CORRIGENDUM-I

Tender Notification No.: IIMT/2021-22/IT/HBC/02; Dated 18.05.2021

Notice Inviting Tender for Supply, Installation, Testing and Commissioning of Audio-Visual Materials (Cameras, Speakerphones, Mounting Brackets, Stands Etc.) For Setting up the Hybrid Classrooms in IIM Tiruchirappalli

Corrigendum/Amendments/Extension in the tender document

CEILING PLAN - 80 seater

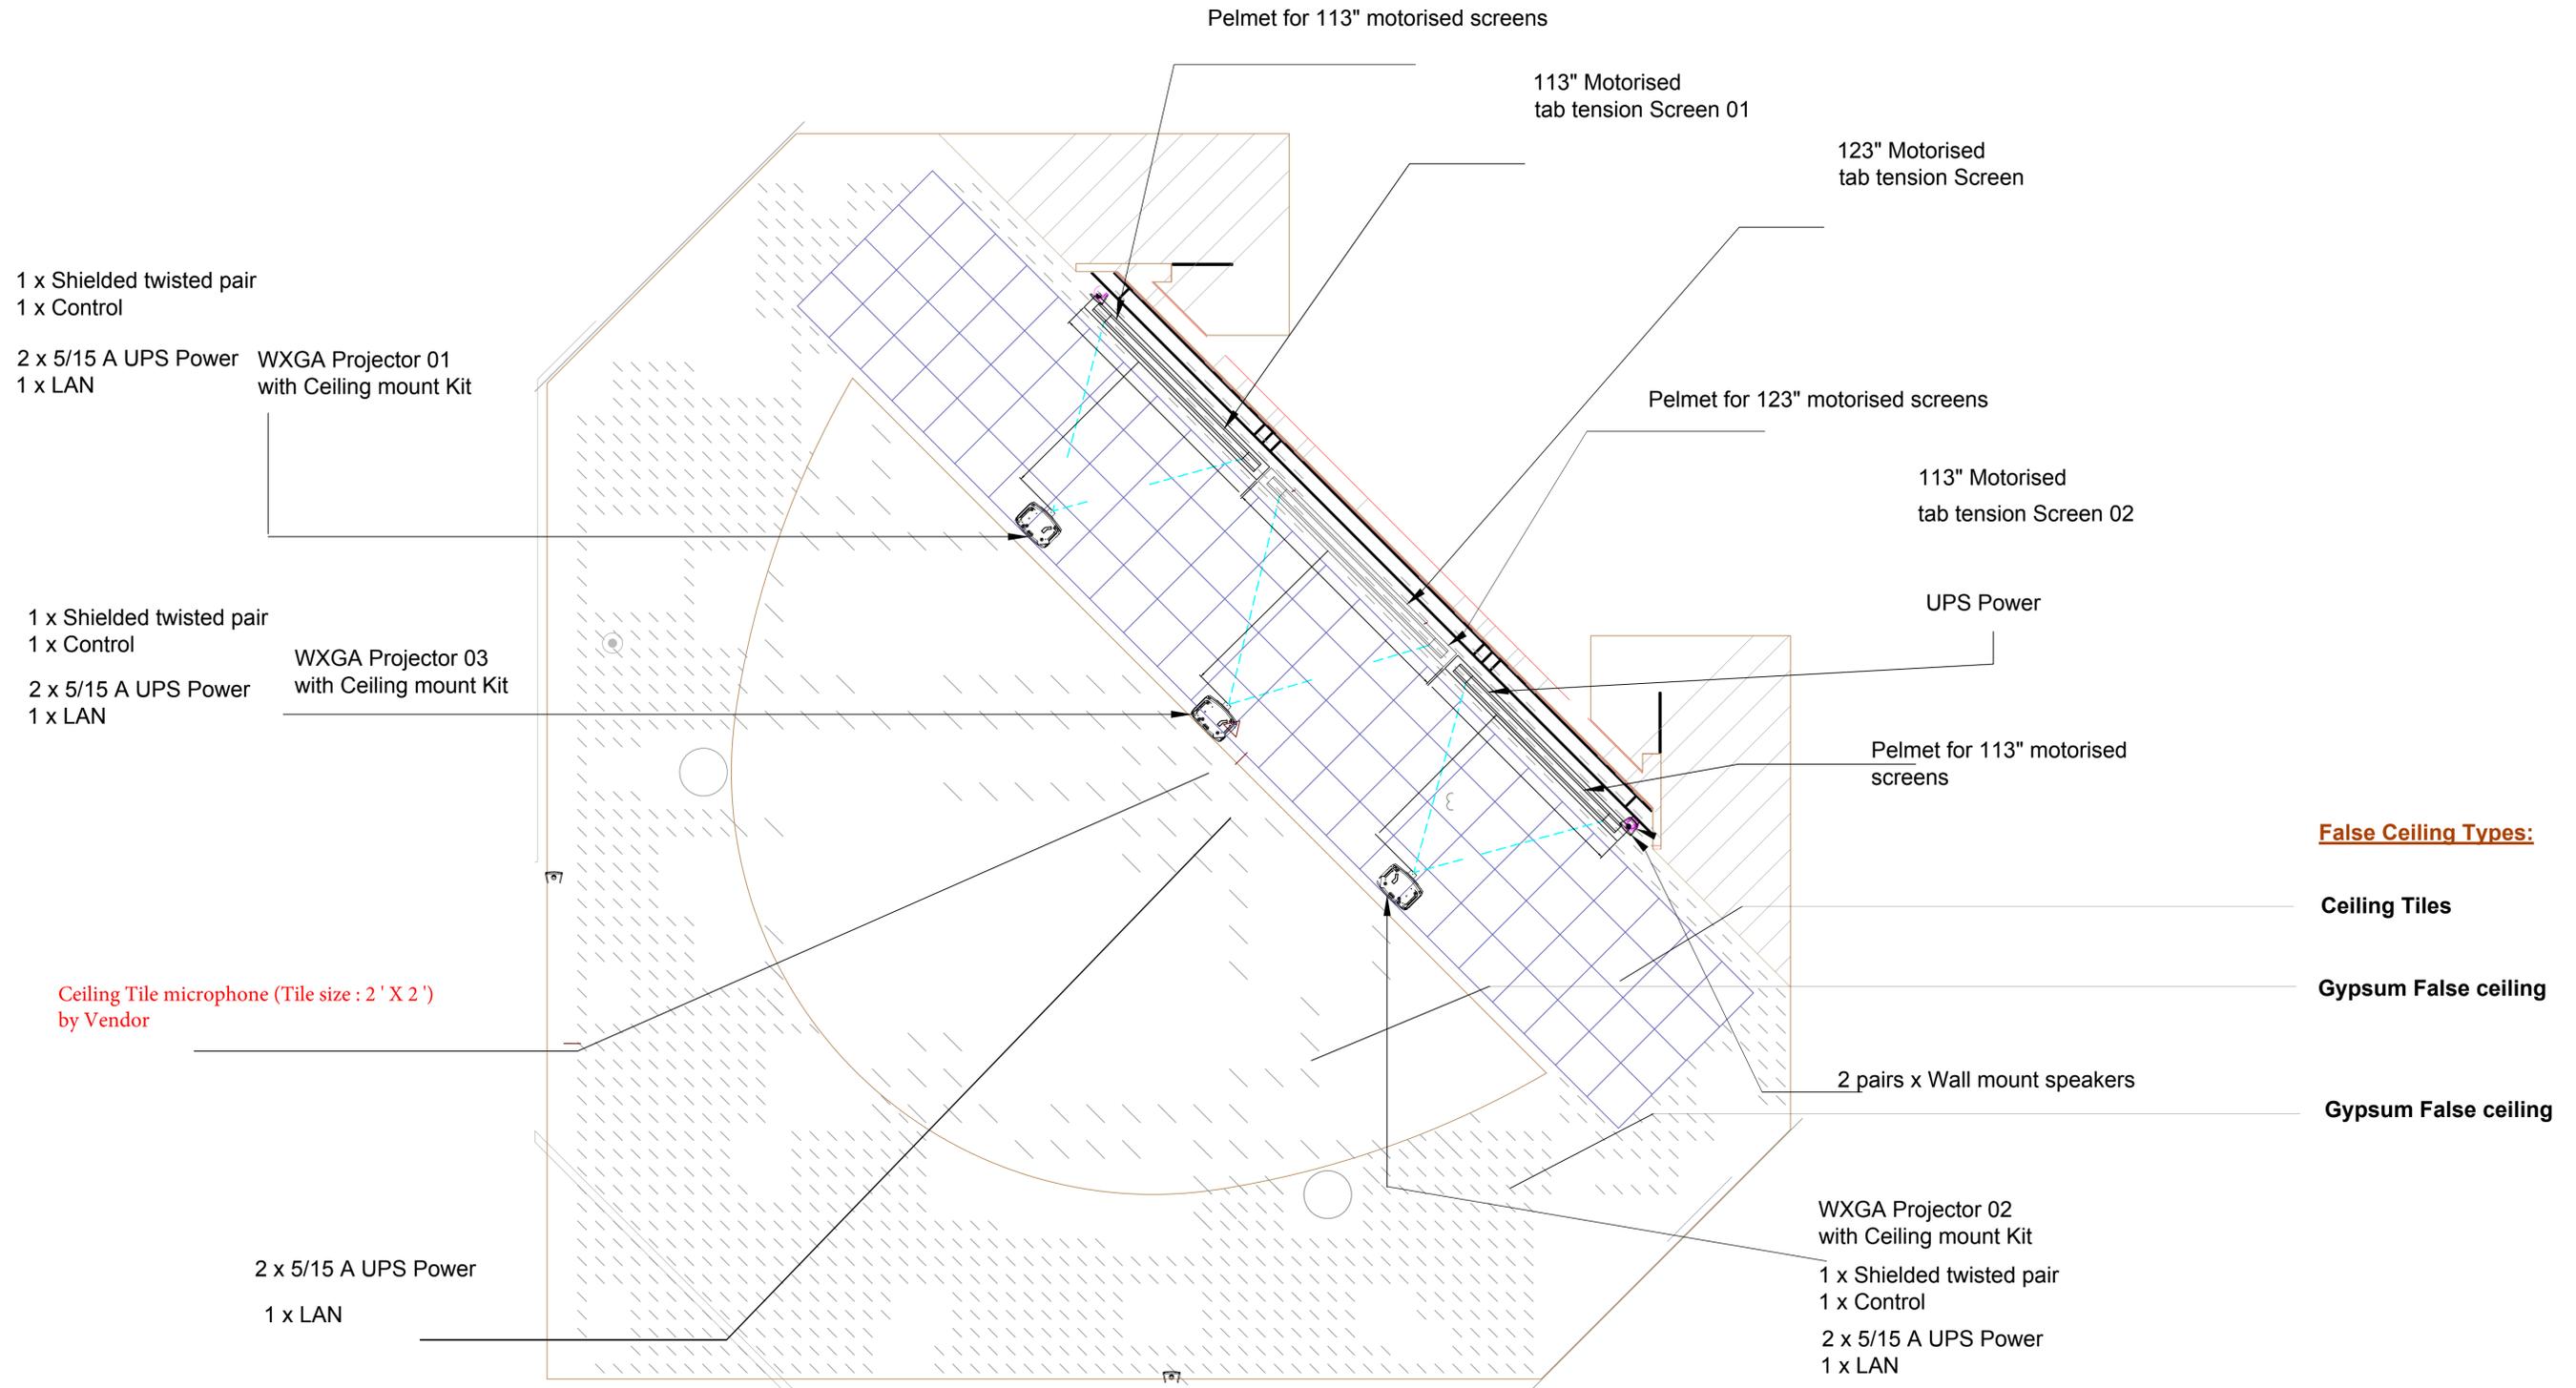
1. The removable tiles (2 X 2') are fixed in front of the screens through which the cable laying can be done.
2. If the installation causes any damage in the gypsum false ceiling, then the same has to be corrected by the vendor.
3. The vendor has to install the ceiling microphone at the required height for maximum performance (voice capture).
4. The conduits are already available on the floor (2.8 Mtrs) and the wall (3.8 Mtrs) through which the cable has to be laid and the conduits are required only at the ceiling (Approximate length : 5 Meters)
5. Please note the following points for reference:

BLOCK SCHEMATICS OF SOUND REINFORCEMENT & PRESENTATION SYSTEM FOR 80 SEATER (Existing and New)

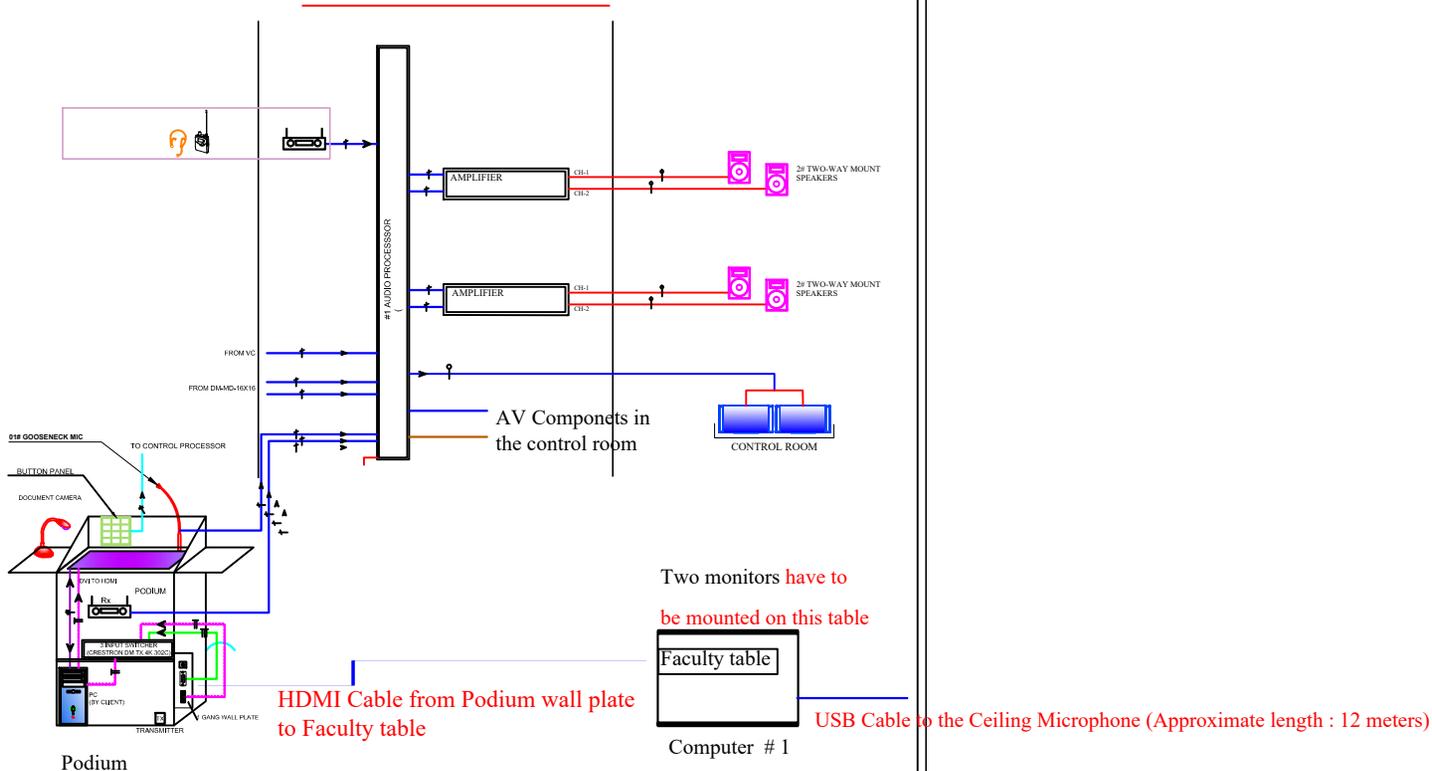
HDMI Cable from Podium wall plate to Faculty table

USB Cable to the Ceiling Microphone (Approximate length : 12 meters)

Two monitors have to be mounted on this table

Camera and mounting stand have to be installed behind this table. Camera should be connected with the computer installed in the student table

Camera and mounting stand have to be installed behind this table. Camera should be connected with the computer installed in the student table (Approximate length : 3 to 5 Meters depending on the positioning of camera)

1. Zoom will be connected from both computer #1 and computer # 2 simultaneously .
2. The video input will be feeded from Computer # 2 (Student table- first row) wherein Camera is connected.
3. The audio (speaker and Microphones) have to be feeded from the Computer # 1 (Faculty table).
4. Note the following for reference:

CEILING PLAN - 50 seater

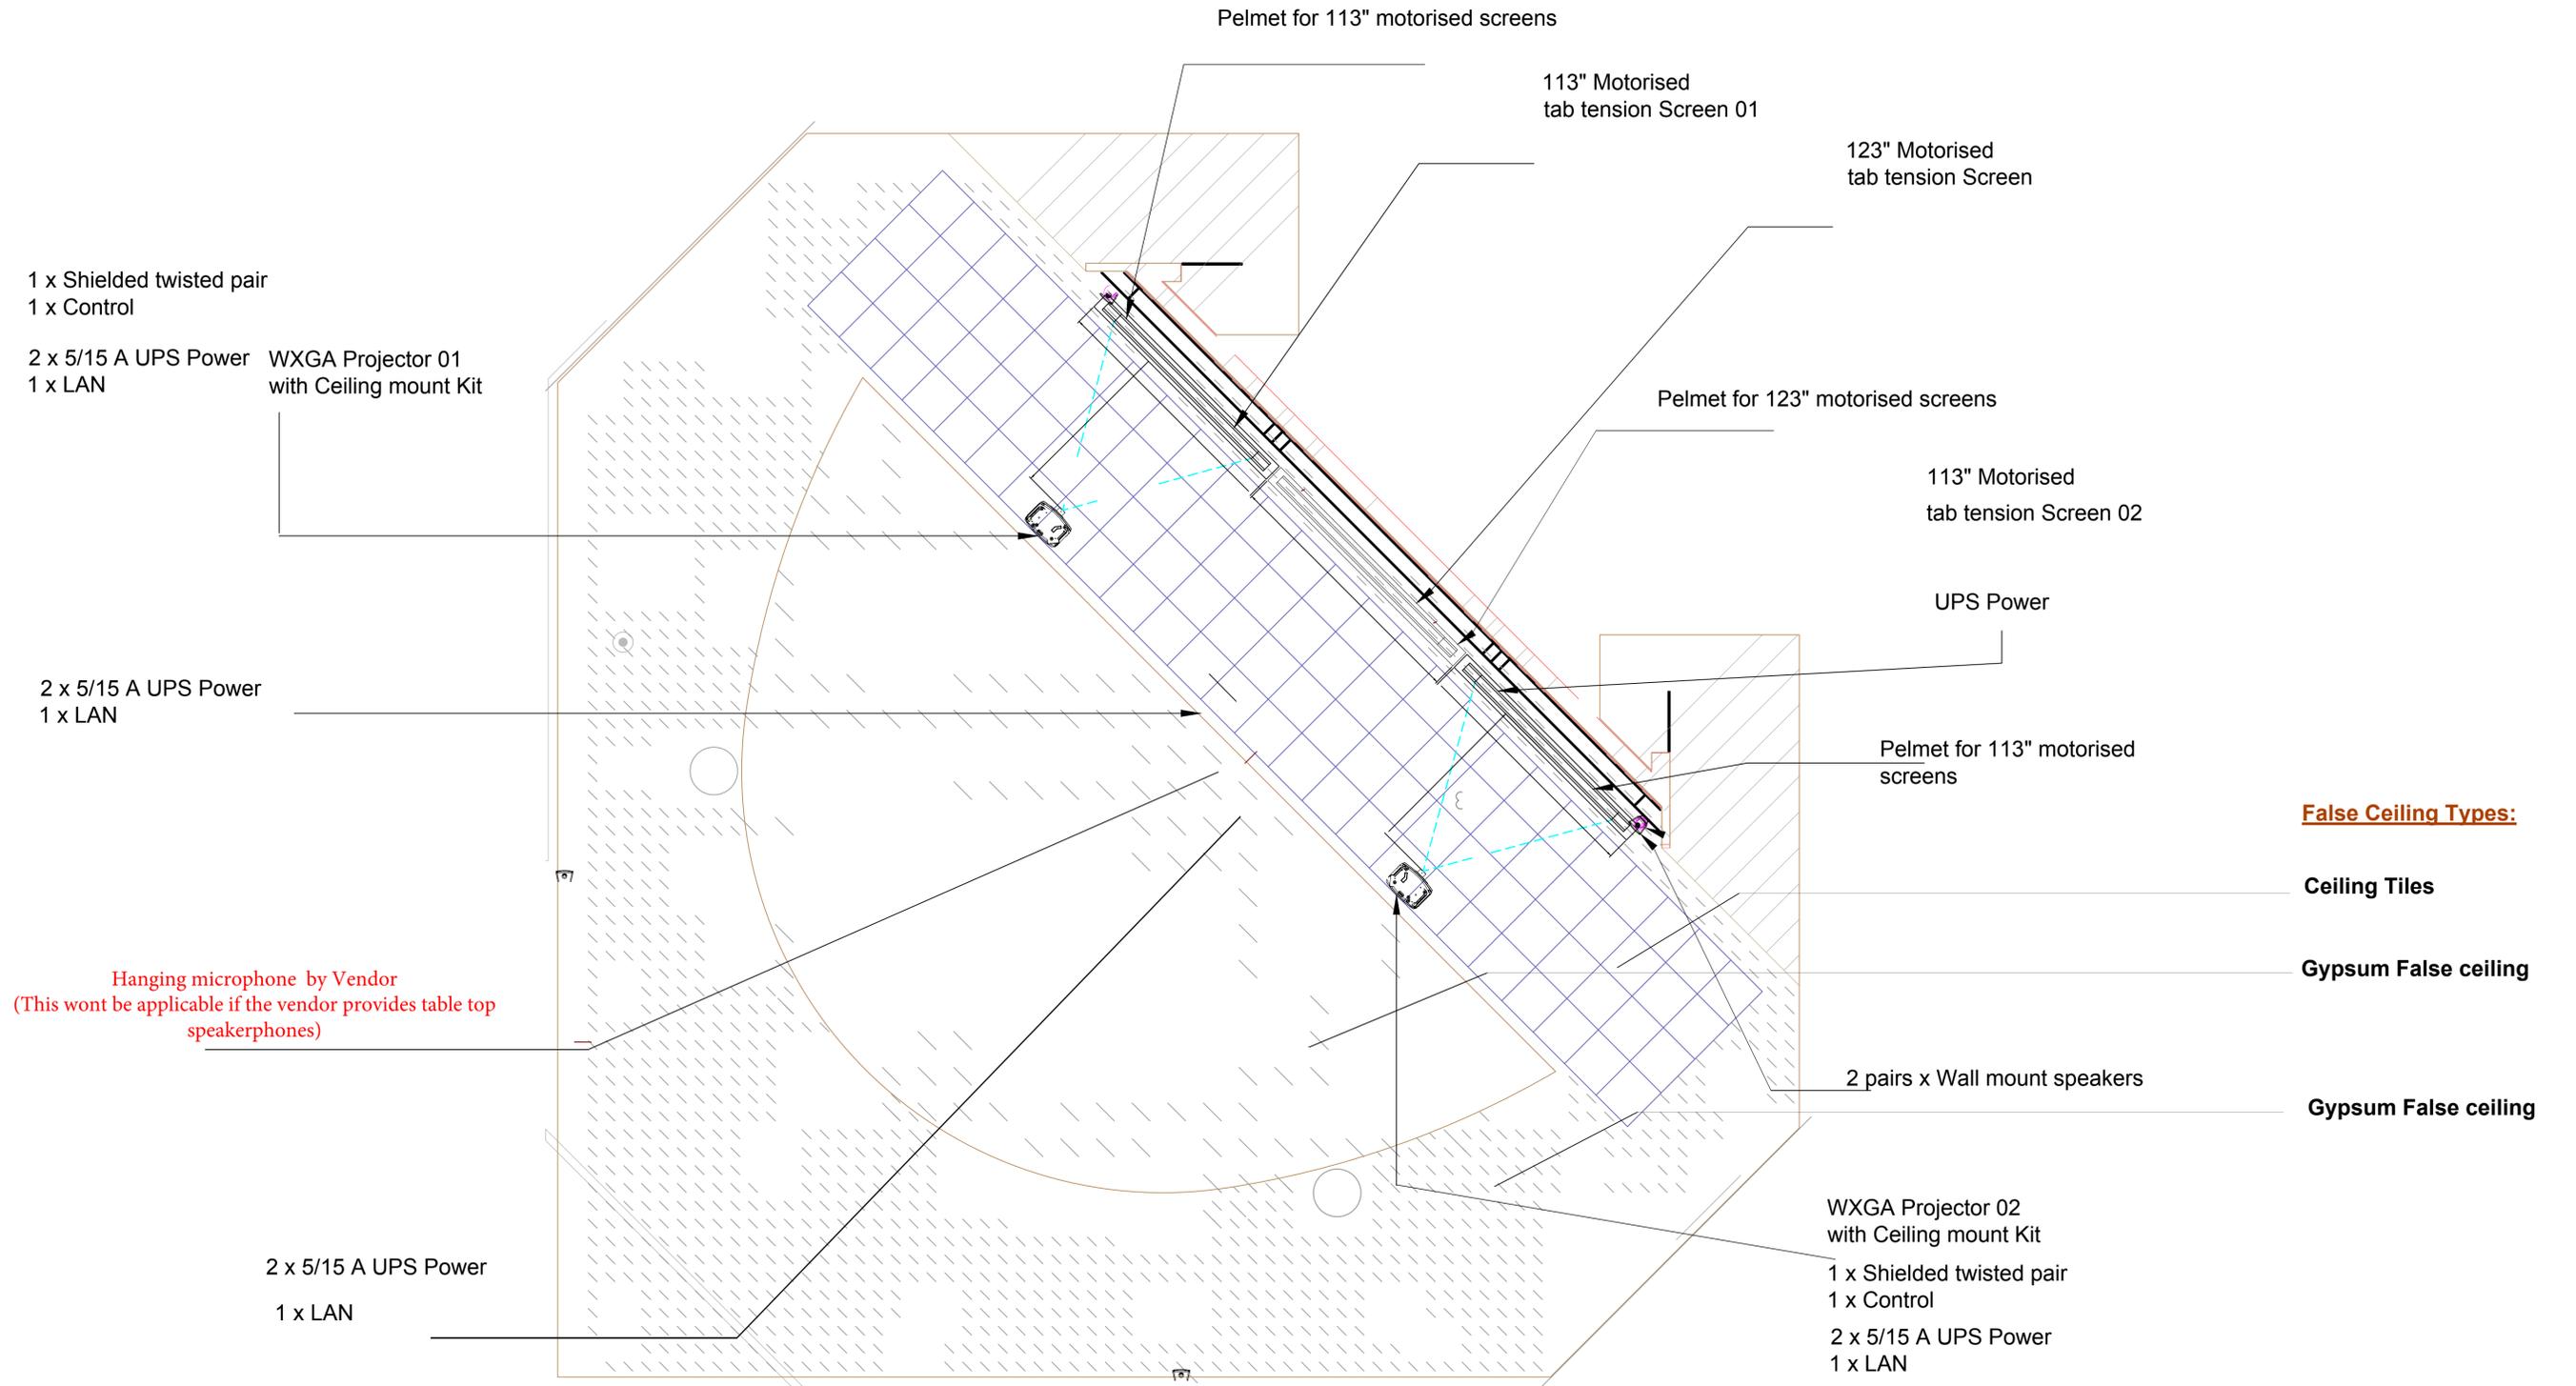
1. The removable tiles (2 X 2') are fixed in front of the screens through which the cable laying can be done.
2. If the installation causes any damage in the gypsum false ceiling, then the same has to be corrected by the vendor.
3. The vendor has to install the hanging microphone at the required height for maximum performance (voice capture). In case of speaker microphones, the same have to be installed on floor stands at suitable position/location for maximum coverage.
4. For the installation of hanging mics, the conduits (1" dia) are already available on the floor (2.8 Mtrs) and the wall (3.8 Mtrs) through which the cables may be laid and the new conduits are required only at the ceiling (Approximate length : 5 Meters)
5. Please note the following points for reference:

BLOCK SCHEMATICS OF SOUND REINFORCEMENT & PRESENTATION SYSTEM FOR 50 SEATER (Existing and New)

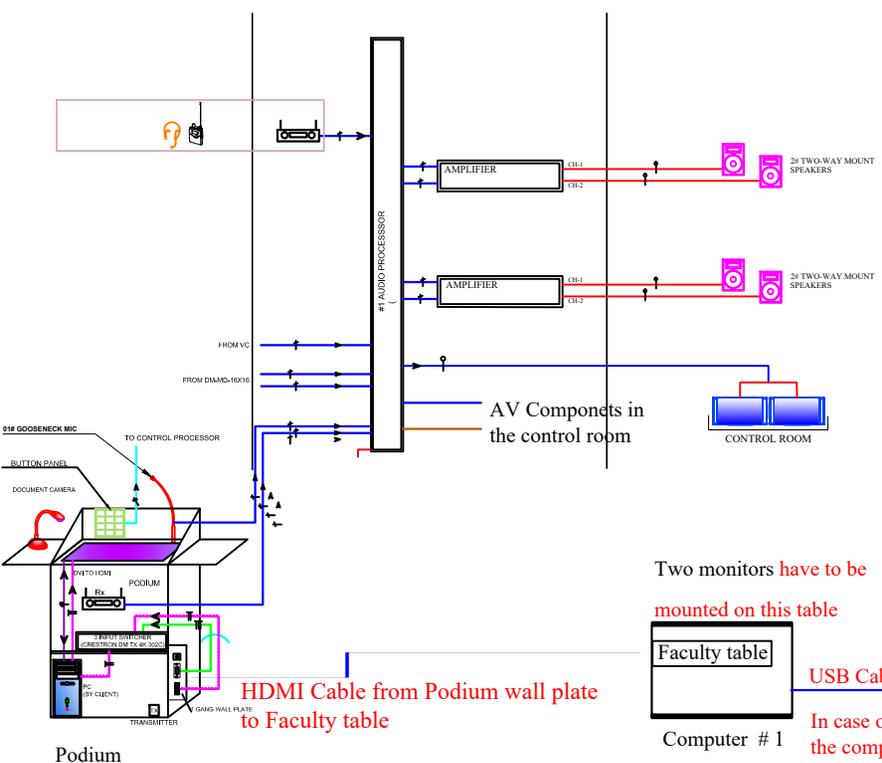
Camera and mounting stand have to be installed behind this table. Camera should be connected with the computer installed in the student table

Camera and mounting stand have to be installed behind this table. Camera should be connected with the computer installed in the student table (Approximate length : 3 to 5 Meters depending on the positioning of camera)

USB Cable to the hanging Microphone (Approximate length : 12 meters).

In case of table top **Speakerphones**, the same have to be installed at both sides of the faculty table and the cable length from the computer to the first speakerphone should be 5 meters and the cable length from one speakerphone to the extension speakerphone should be 10 meters approximately. Two height adjustable floor stands/tripods to place the speakerphones (2 Nos) at suitable locations should be provided by the vendor for the table top mics (wooden/steel/custom made /ready made).

1. Zoom will be connected from both computer #1 and computer # 2 simultaneously .
2. The video input will be feeded from Computer # 2 (Student table- first row) wherein Camera is connected.
- 3.The audio (Speaker and Microphones) have to be feeded from the Computer # 1 (Faculty table).
- 4.Note the following to know the scope of work of the vendors:
